Re: Blake's Lotaburger #27 Drive-Thru
2301 Carlisle Blvd. NE
Traffic Circulation Layout
Architect's Stamp 06-30-2022 (H16-D106)

RE: Blake's Lotaburger #27 Drive-Thru | Traffic Circulation Layout Review letter dated June 21, 2022.

SITE PLAN-
TRAFFIC CIRCULATION LAYOUT

BLAKE'S LOTABURGER
#27 DRIVE THROUGH

AS-104

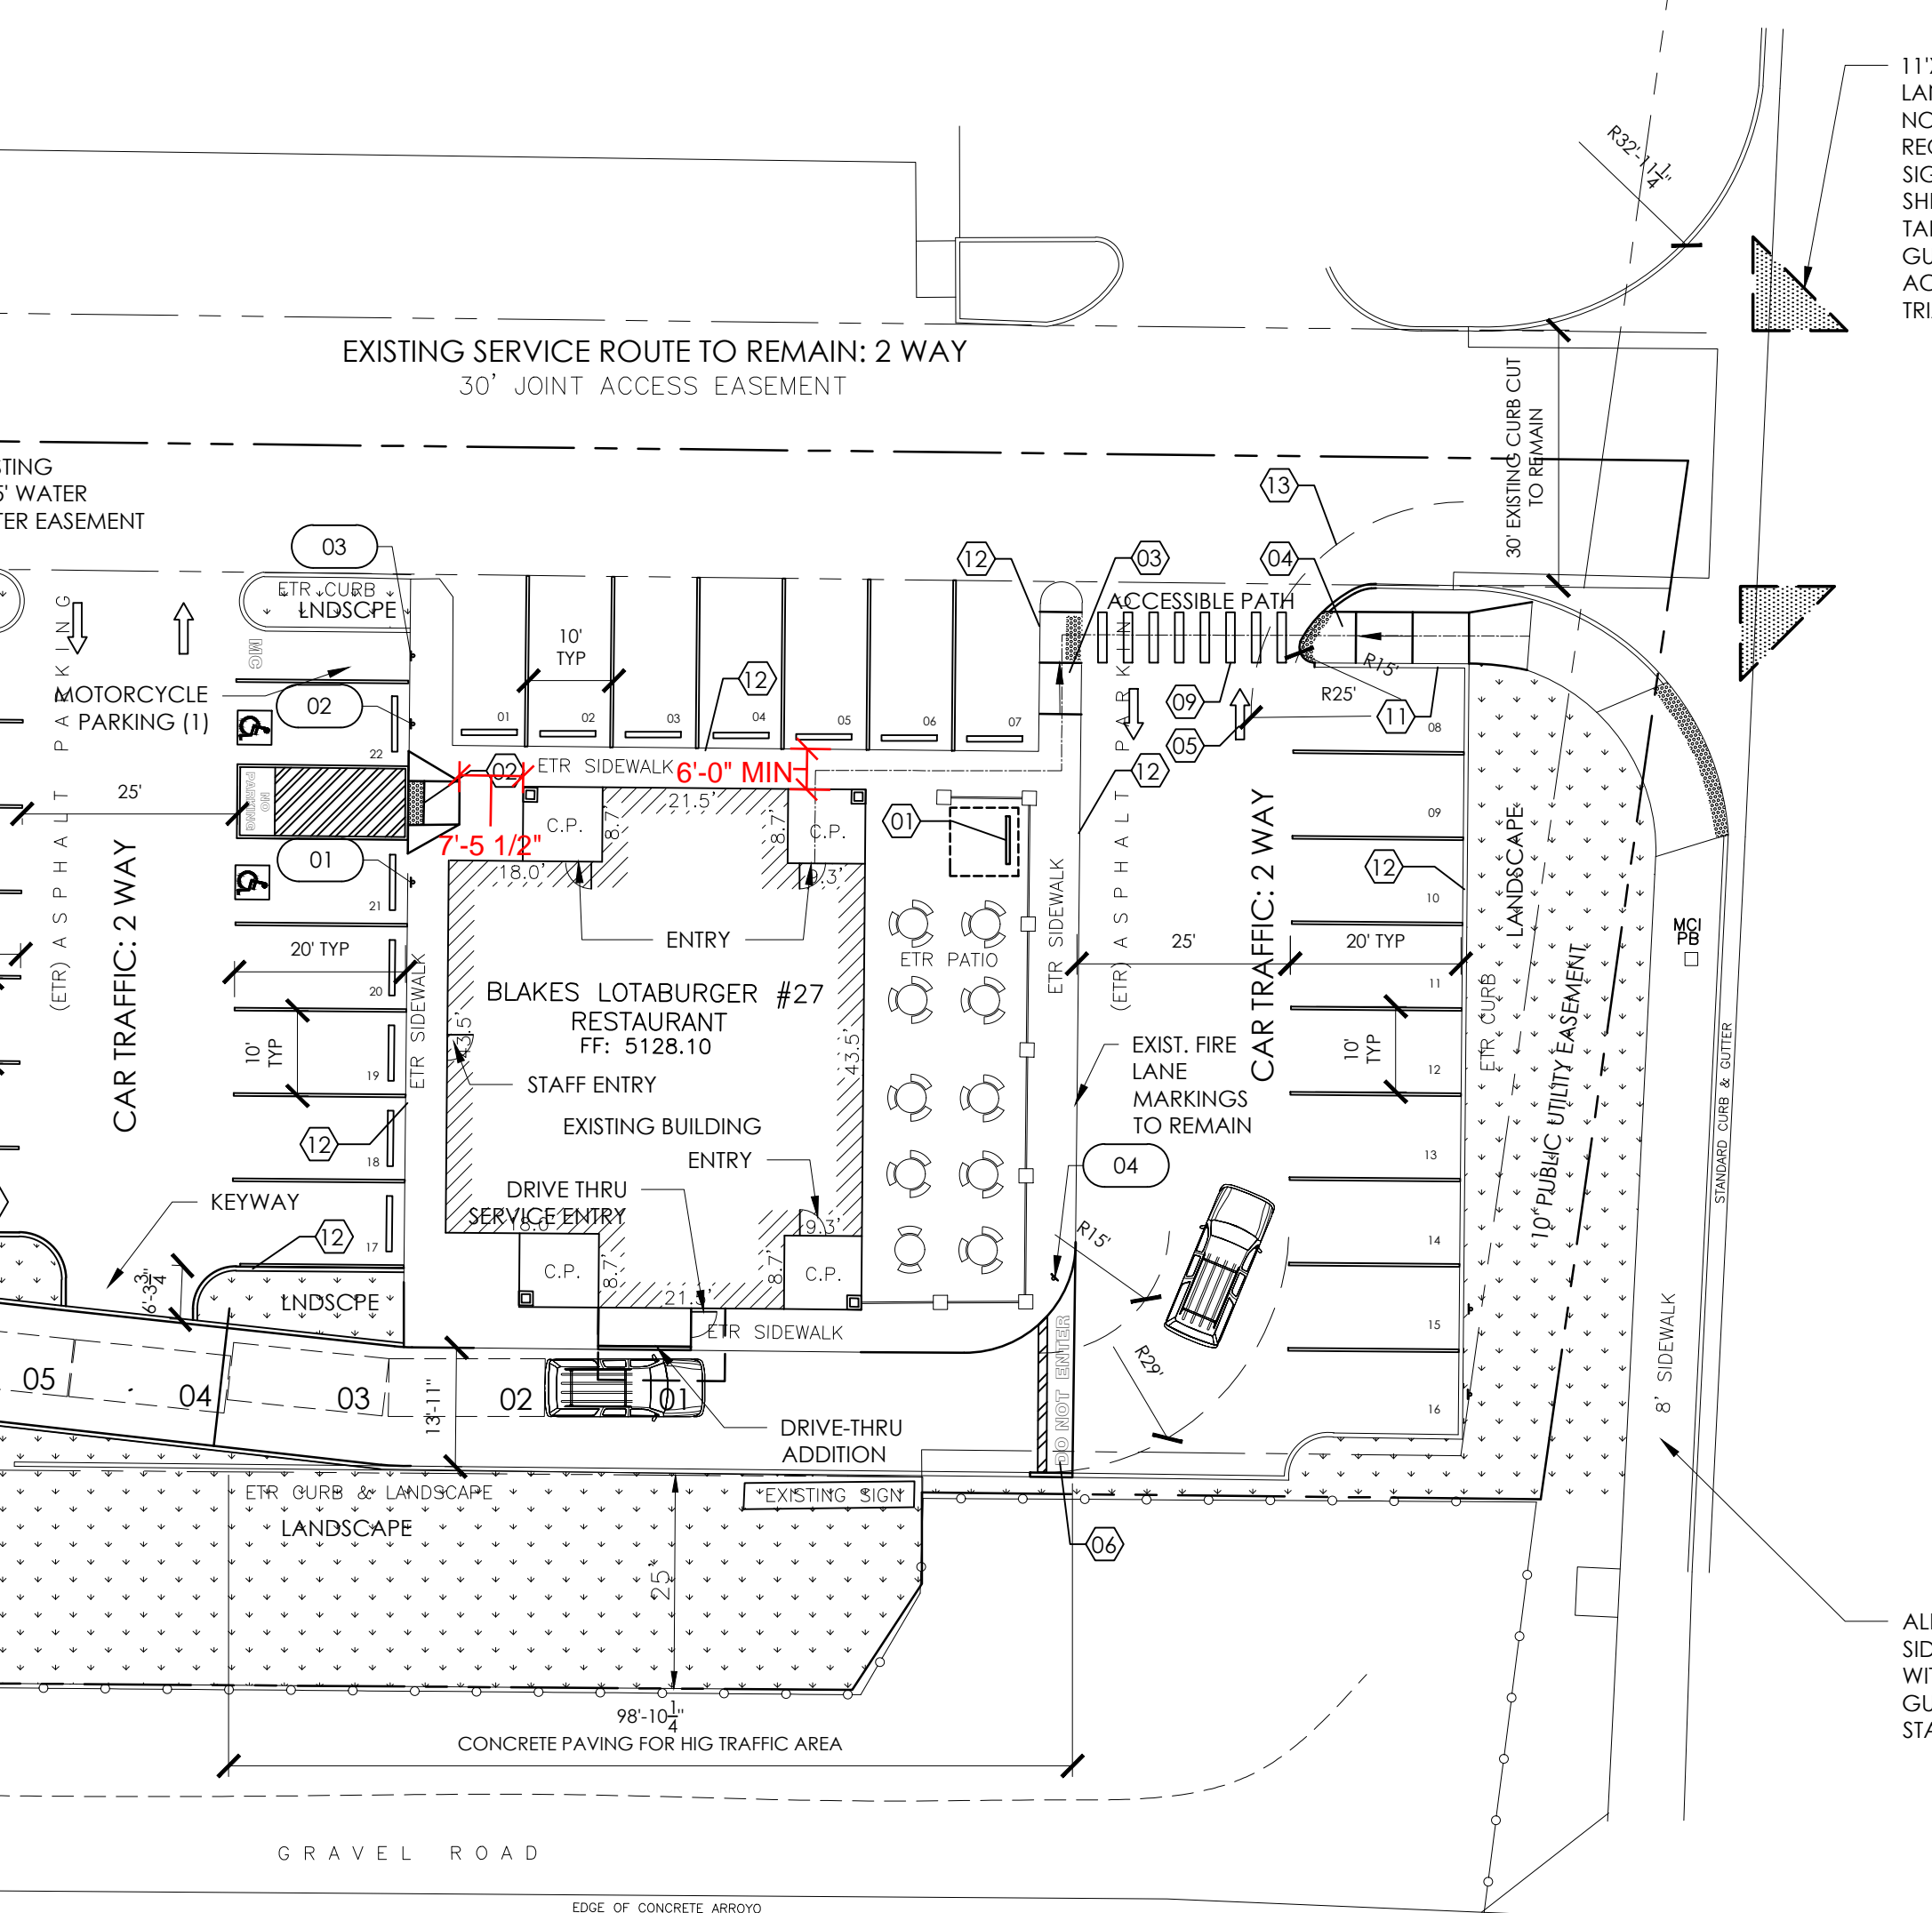
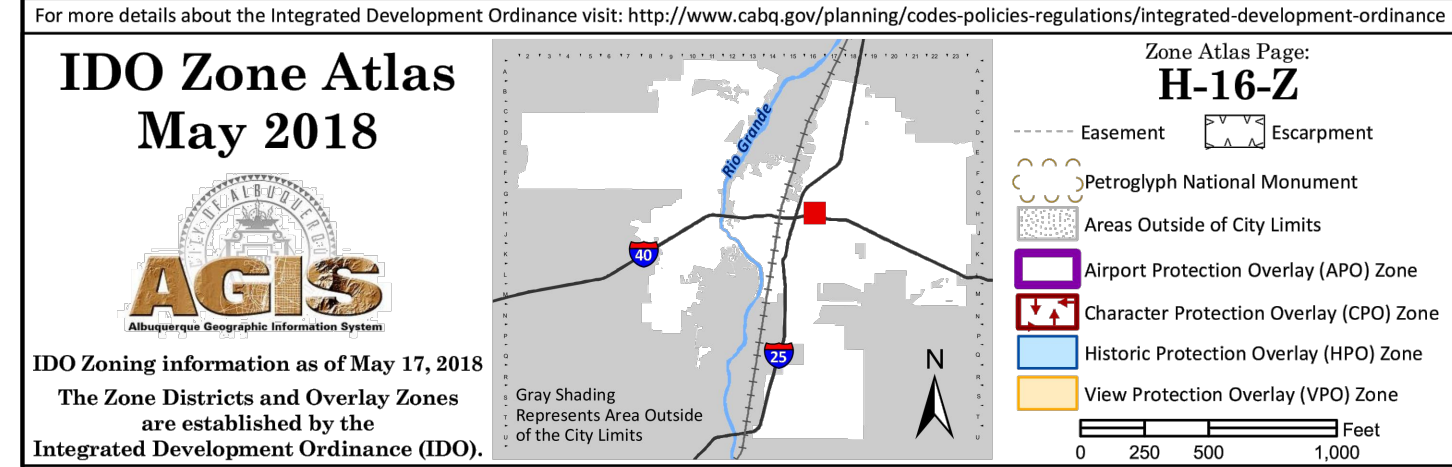
1. Vicinity Map:
 - a. Vicinity Map provided on Sheet AS-104, titled, "Project Access"
2. Parking Requirements:
 - a. See Sheet AS-104, right column labeled, "Parking Requirements"

3. Stamped Drawings:
 - a. Attached AS-103 and AS-104 are signed and stamped by Rebecca Snyder, Registered Architect #: 5814
4. General Notes:
 - a. AS-101 is not needed for the Traffic Circulation Layout application, note has been removed.

6. Proposed Drive-Thru Bypass:
 - a. Bypass has been replaced with keyway required for dead-end parking.
7. ADA Curb Ramp:
 - a. Keynotes 01, 02, and 03 added to refer to ADA Ramp configurations on AS-103.

- a. Keynotes added to clarify detail locations on the TCL plan.
- 9. Pavement Markings + Striping:
 - a. Refer to details D1, D2, and D3 on Sheet AS-103 for pavement marking details. Striping to be per layout on plan. Keynotes added to refer locations of specific details. Lettering height to be typical for all.

- 10. Easements + Rights of Way
 - a. Existing easements and rights of way are now identified on the plan, specifically:
 - i. Carlilse Boulevard + Median (R.O.W. Varies)

- b. Existing curb cut at 30' Joint Access Easement to remain. This access has been permitted through NMDOT for this project (due to its proximity to I-40)

- 12. Corner of Carlilse/Access Easement
 - a. Detectable Warning Surface (Truncated Domes) added at existing curb ramp to bring up ramp to ADA standards.

- 15. Bicycle Rack Mounting
 - a. Bicycle rack will be sturdy and anchored to concrete pad, see detail B4/AS-103.
- 16. Bicycle Clear Area
 - a. Clear area of 1' around the parking stall is provided. See outline on TCL plan.

- a. Drive Aisle widths and radii provided on TCL plan.
- 19. Drive Aisle Dimensions
 - a. Main Circulation Road: 24' min. required: 30' Joint Access provided (Existing to Remain)

- b. Two Way Traffic: 22' min. required: 25' provided in parking areas
 - c. Fire Lane: 20' min. required. Existing 25' Fire Lane to remain.
- 20. Turn Radii

- a. Radii dimensions added for all turns. Existing fire truck path to remain, path now showing on the TCL.
- 21. Keyway for dead-end parking:

- 22. ADA Pedestrian Pathway
 - a. Pathway outlined on TCL plan. From the sidewalk along Carlisle, turn West and go down new curb ramp (Detail B3/AS-103) to cross parking lot along striped pedestrian walkway (Detail D1/AS-103) and up new curb ramp in existing island (Detail C3/AS-103) into building at existing Northeast entrance.

- 28. Fire Department
 - a. Fire Lane location and paths are existing to remain.
- 29. One-Way Drive Signage:
 - a. See pavement marking locations on AS-104 TCL plan and details on D3/AS-103.

- 31. Intersection Sight Distance Exhibit
 - a. Provided per Detail, 3/AS-104. Area in prescribed triangle (per DPM) is free from any visual obstruction.

- b. Note: this access has been recently permitted through NMDOT as part of this process (due to proximity to I-40)
- 32. Clear Sight Triangle
 - a. Clear sight triangle and notes moved to intersection of Access road and Carlisle.

- 33. Sidewalk Repair:
 - a. Broken and cracked sidewalk note added to existing sidewalk along Carlisle.

C2

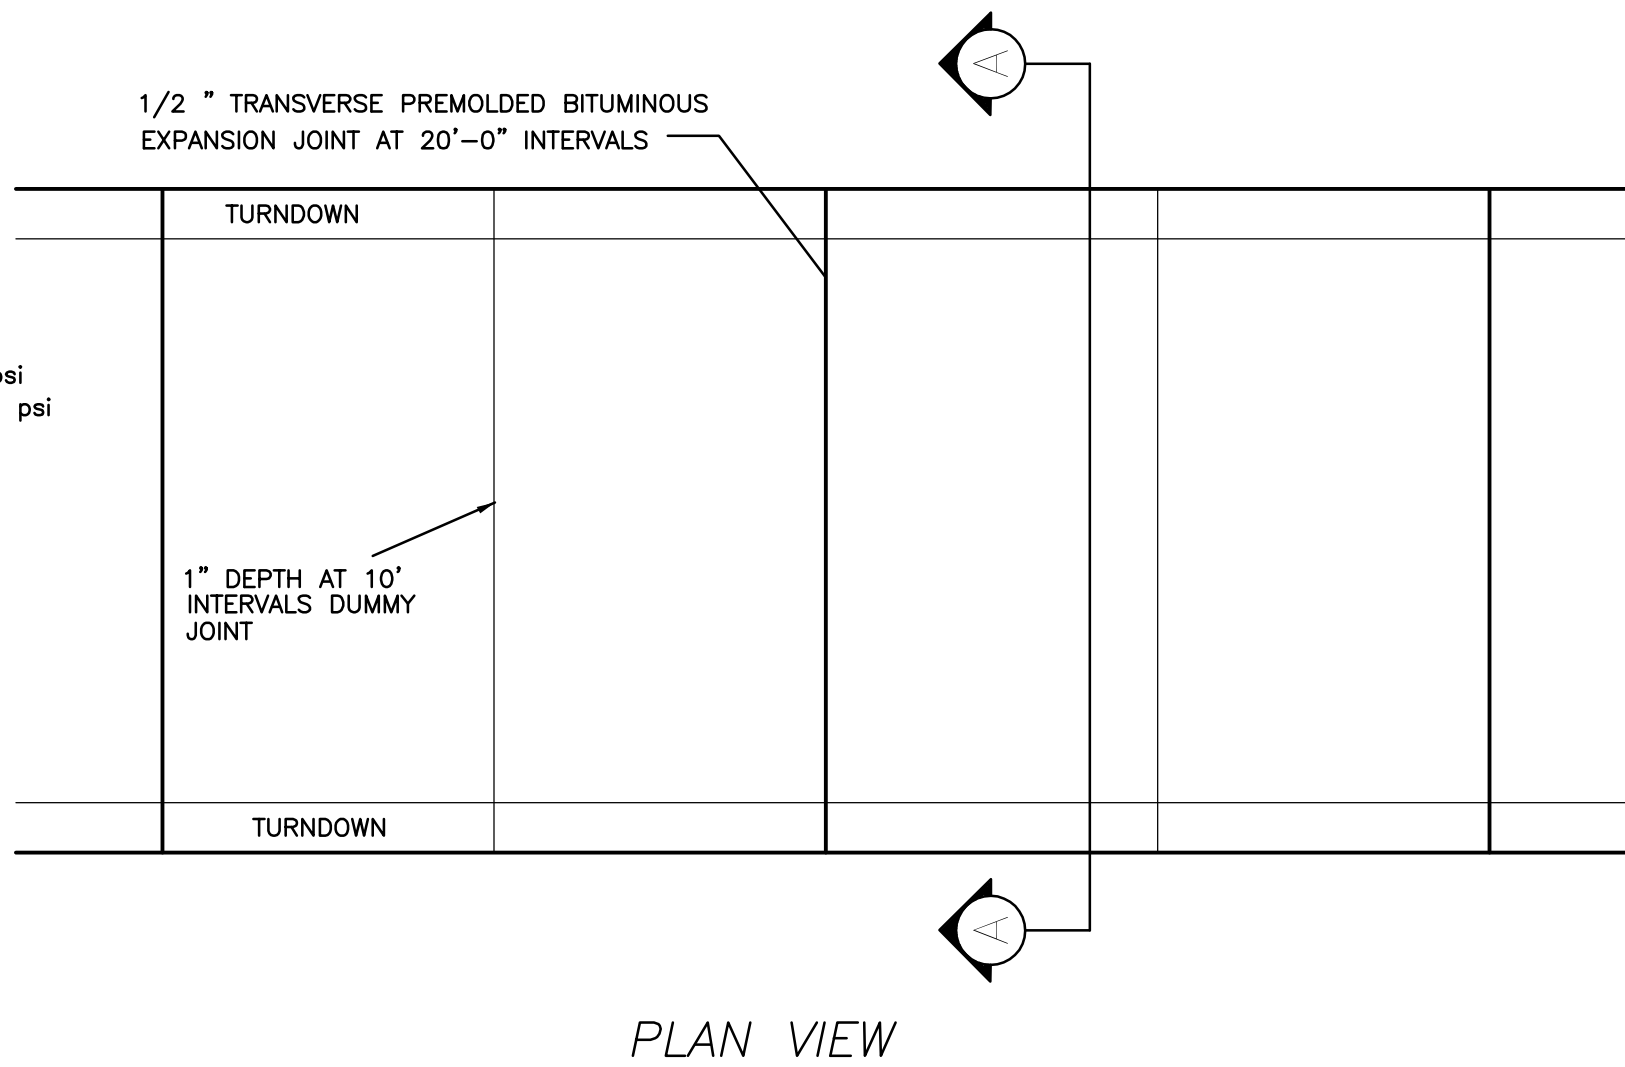
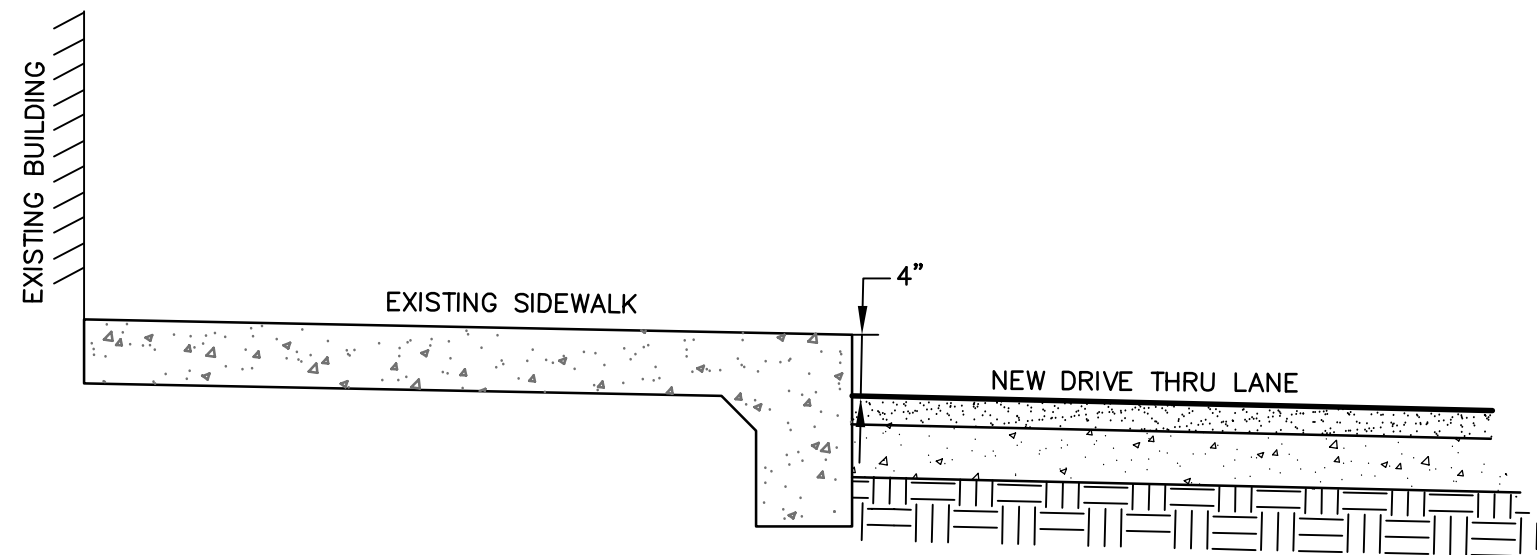
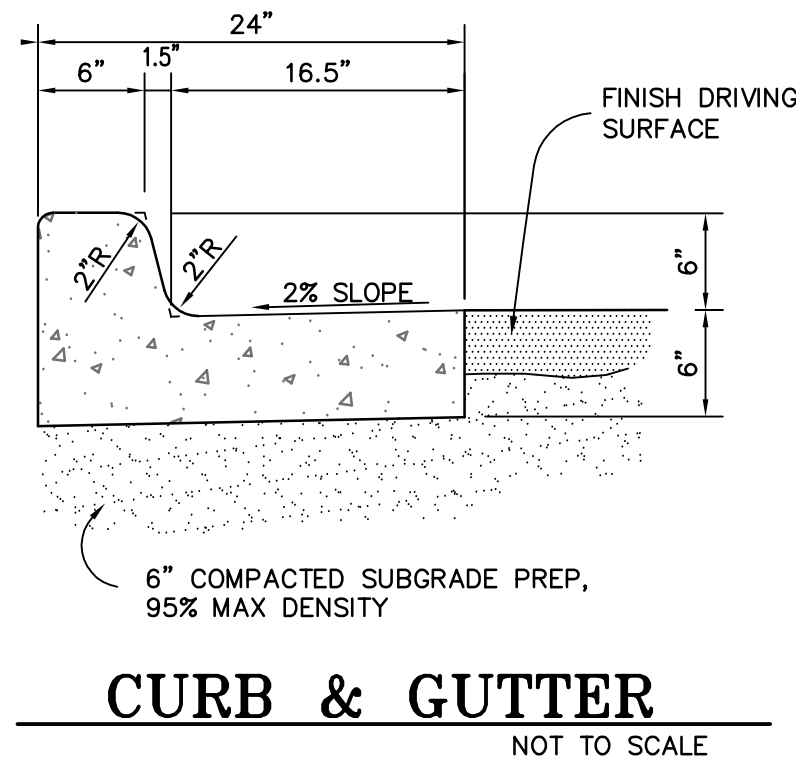
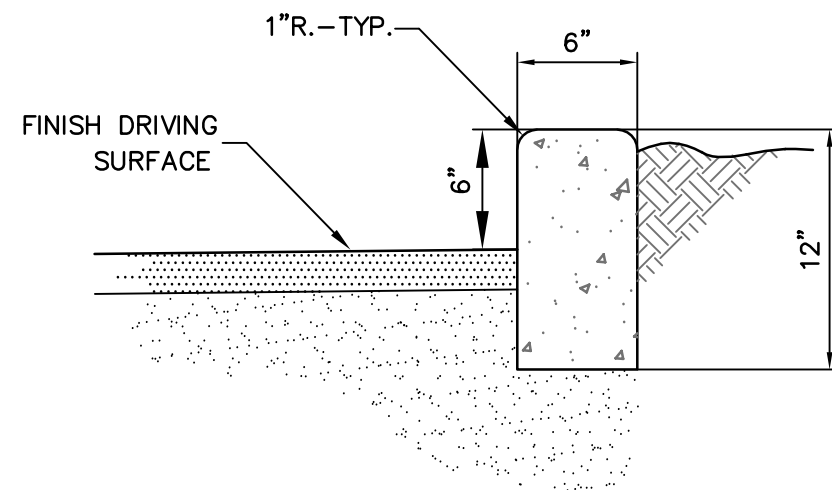
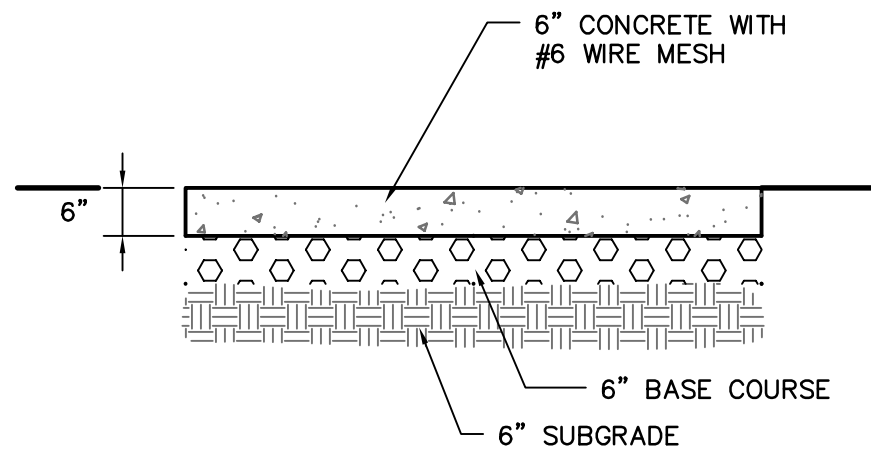
- 25. Barrier Curb
 - a. Curbs called out in key locations per keynotes 11 and 12.
 - b. Added keynote 11 to read as follows, "Barrier Curb – See Civil detail sheet C2"
